Solicitation No. 3450035790

Amendment No. 1

**BRYAN COUNTY
MAINTENANCE FACILITY**

REVISION SUMMARY – ADDENDUM #01

SHEET NAME
WASH SHED
MECHANICAL PLAN
SHEET
WM1.0

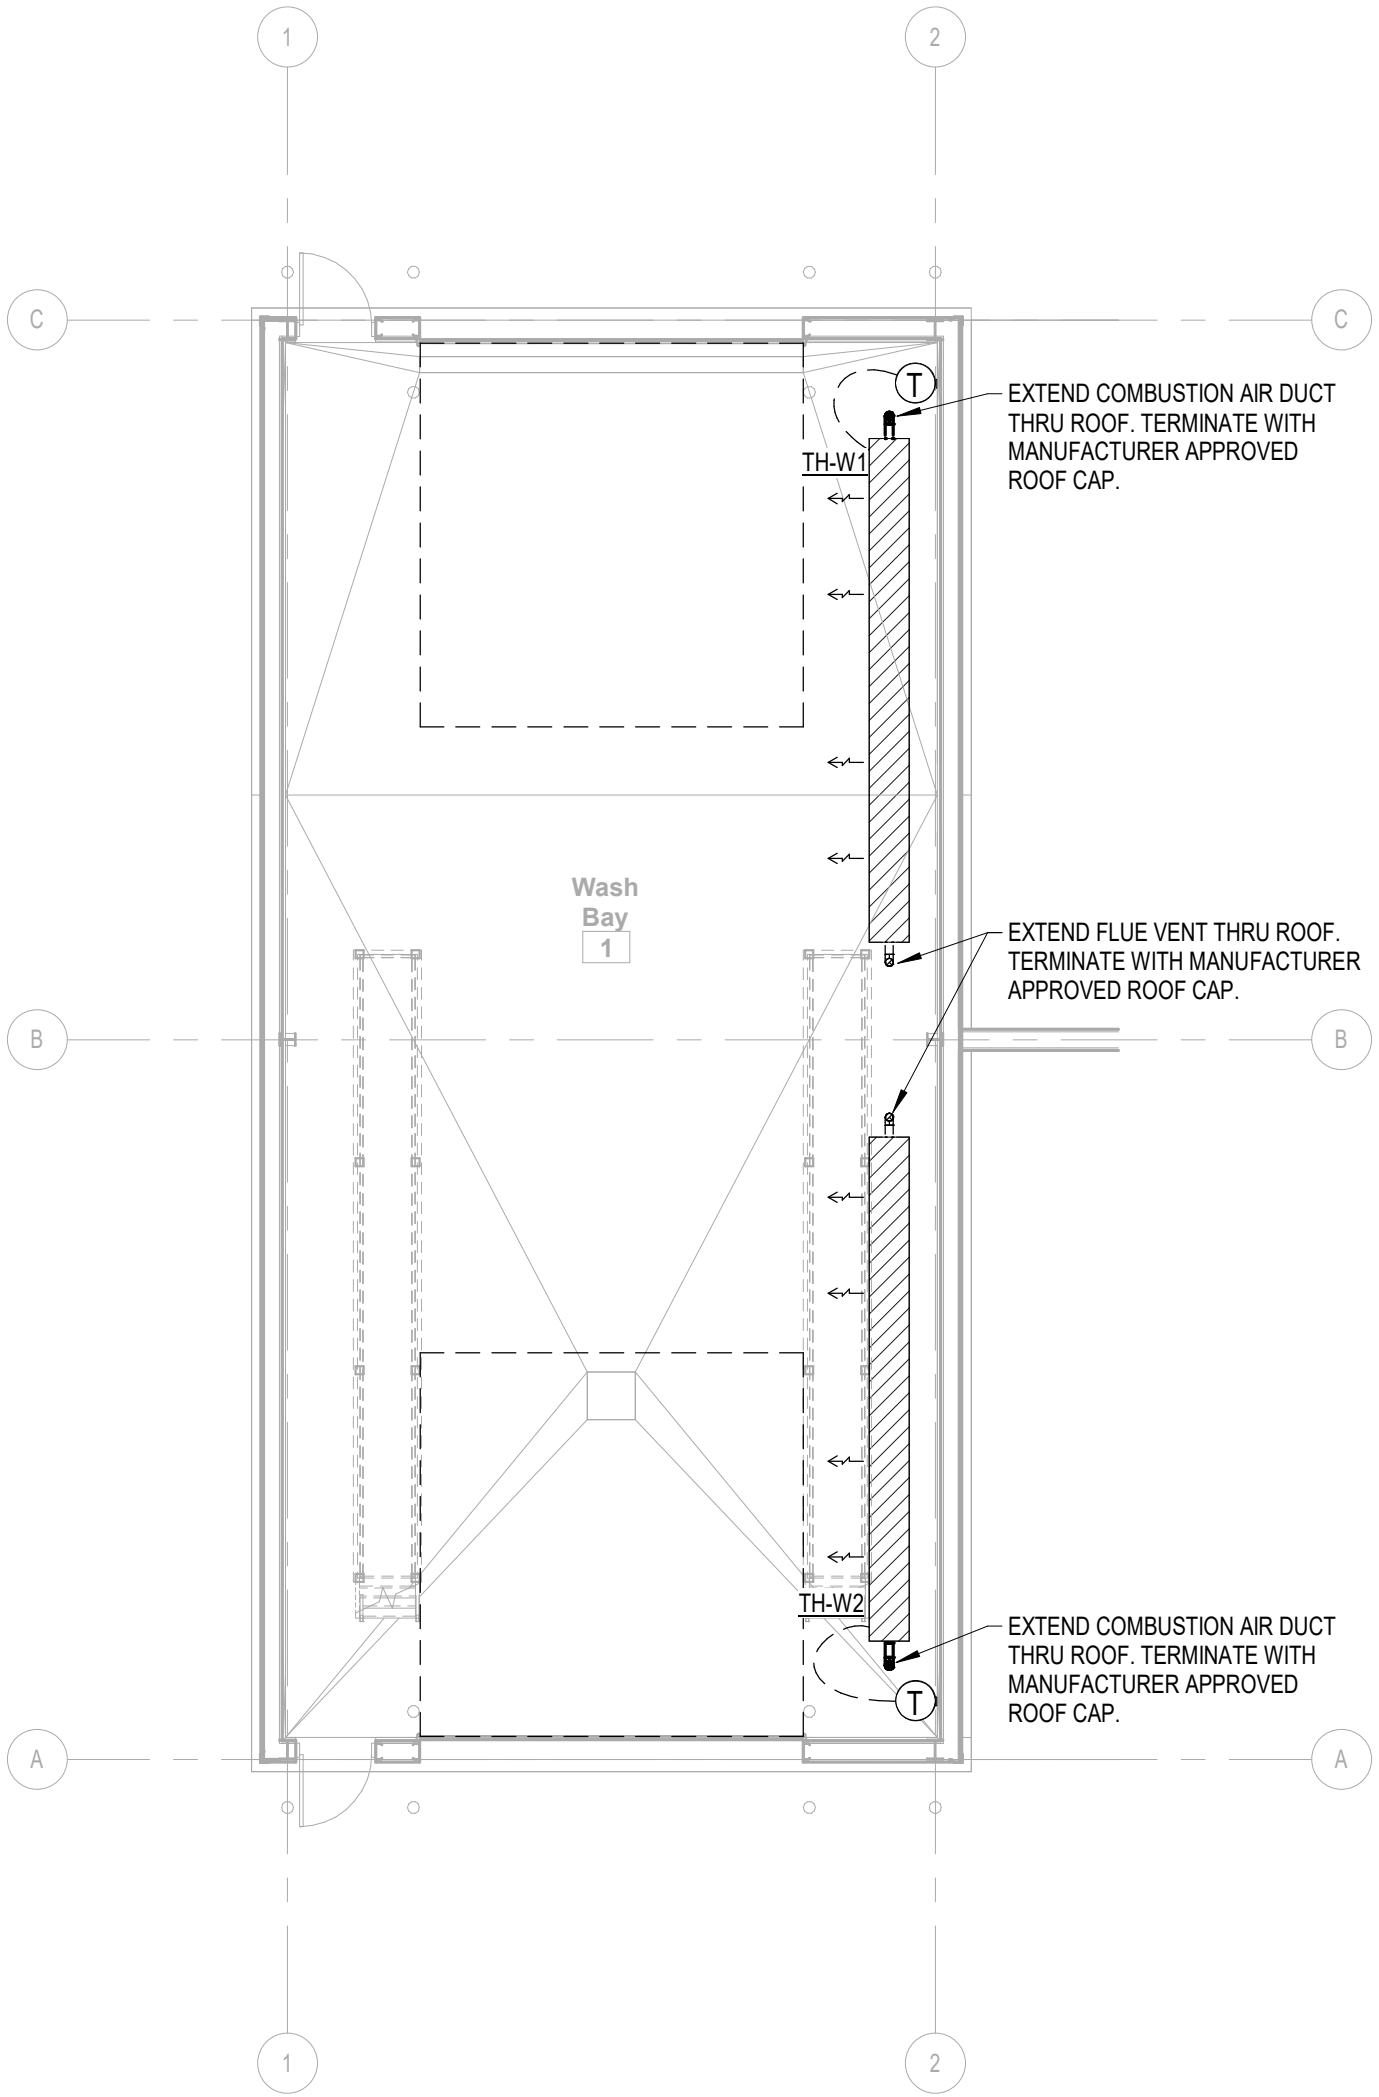
3. TITLE BLOCK CHANGE.

SHEET
EP1.0

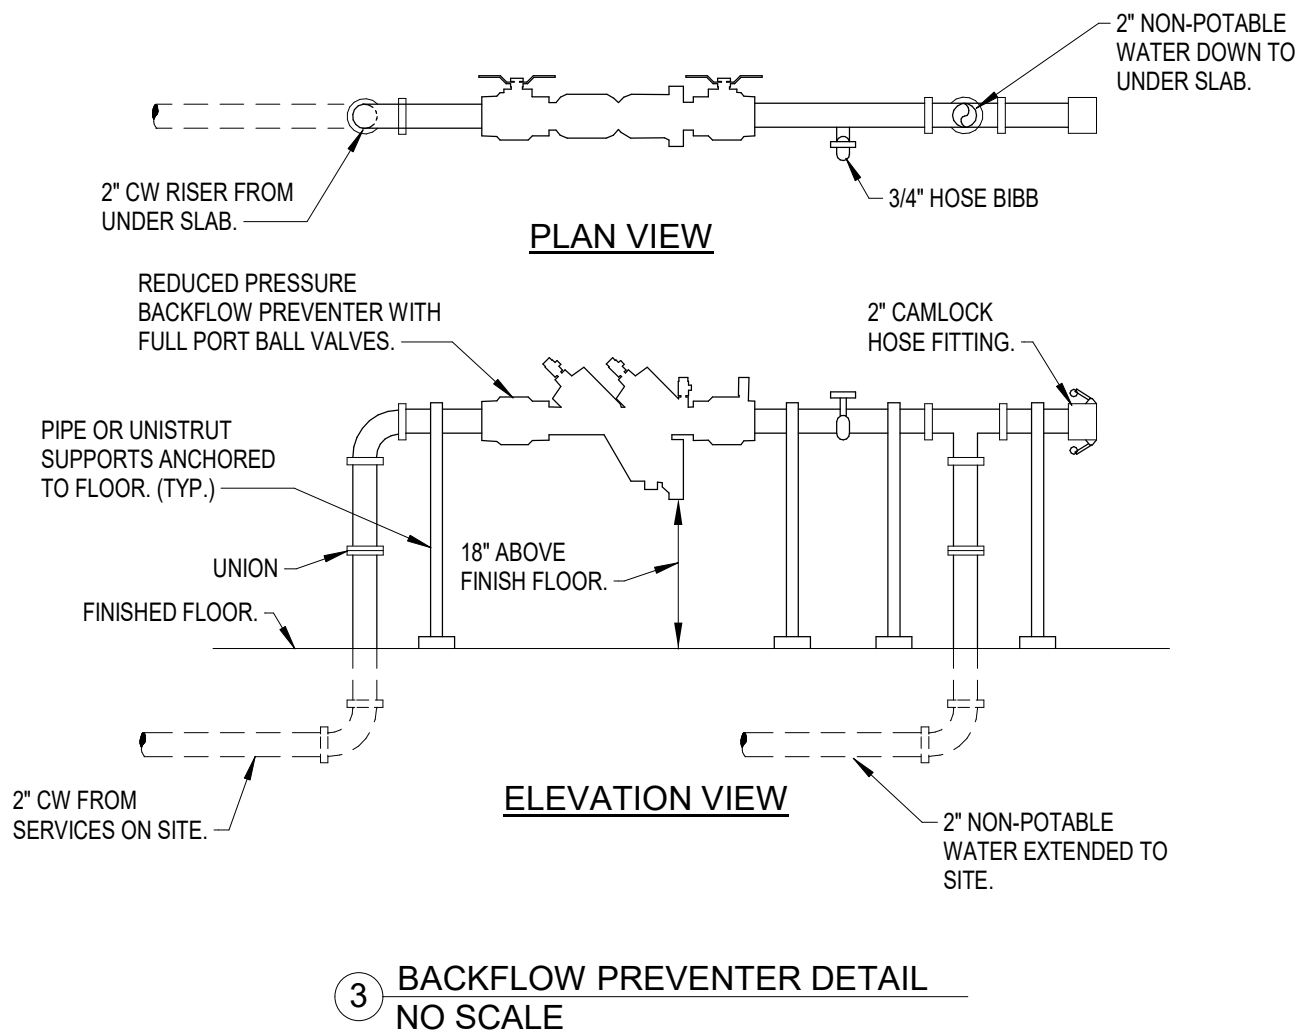
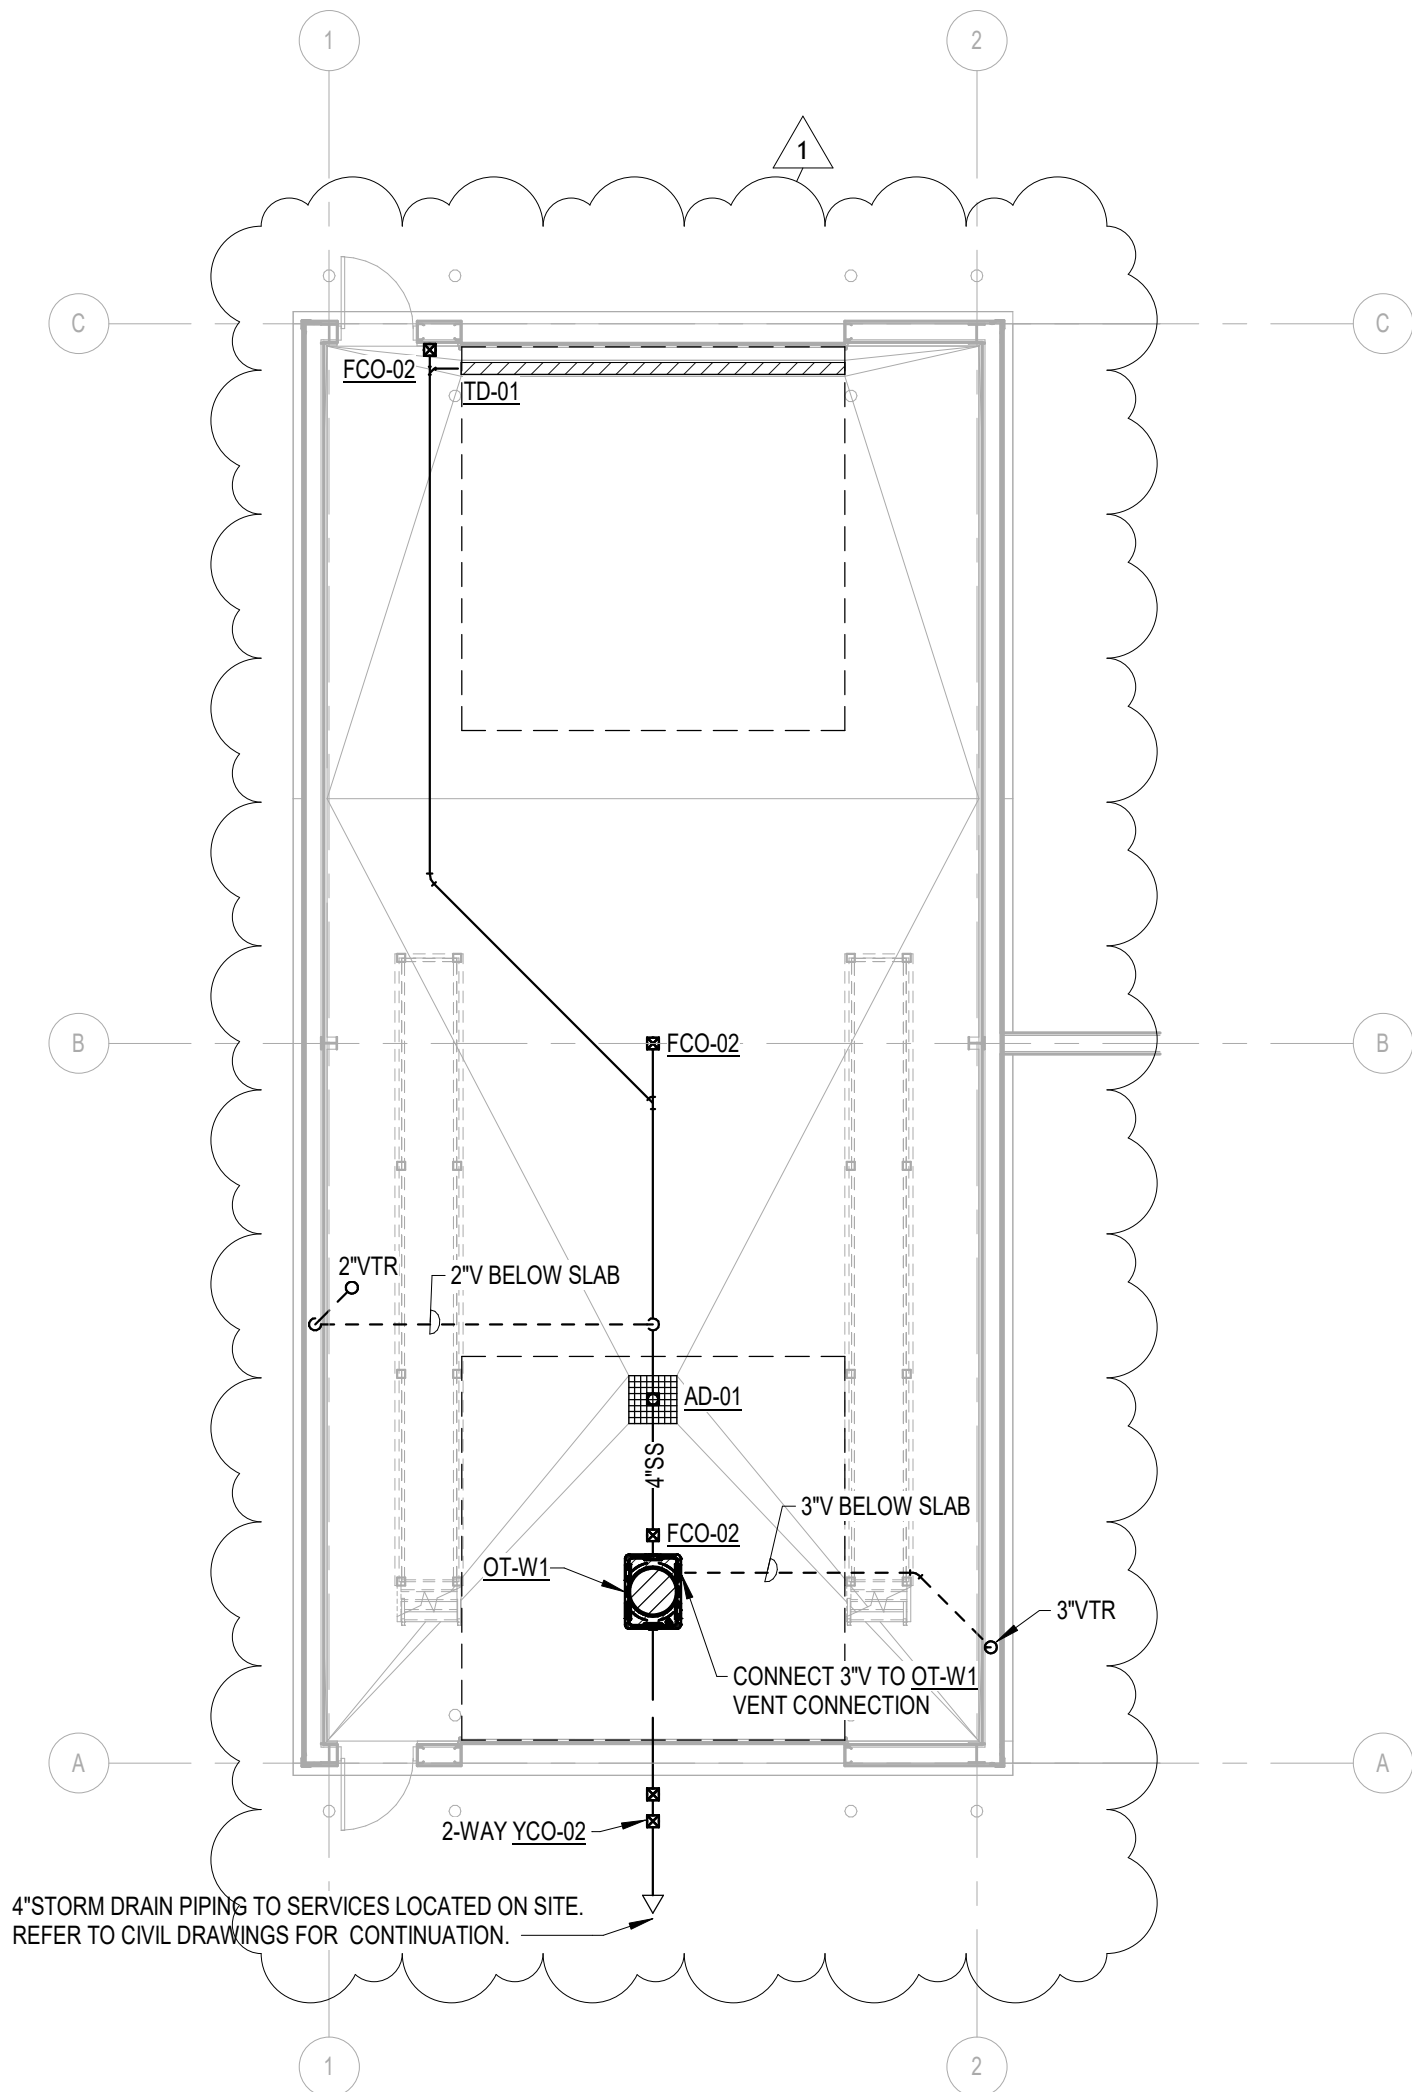
1. SINGLE BAY TO DOUBLE BAY SHOP SHED, TITLE BLOCK CHANGED.

WHOLE SHEET CHANGED.FROM
SINGLE BAY TO DOUBLE BAY
SHOP SHED.

A 25: Sheets EM1.0 and EP1.0 are being replaced. Two shop bays is what is needed for this project.
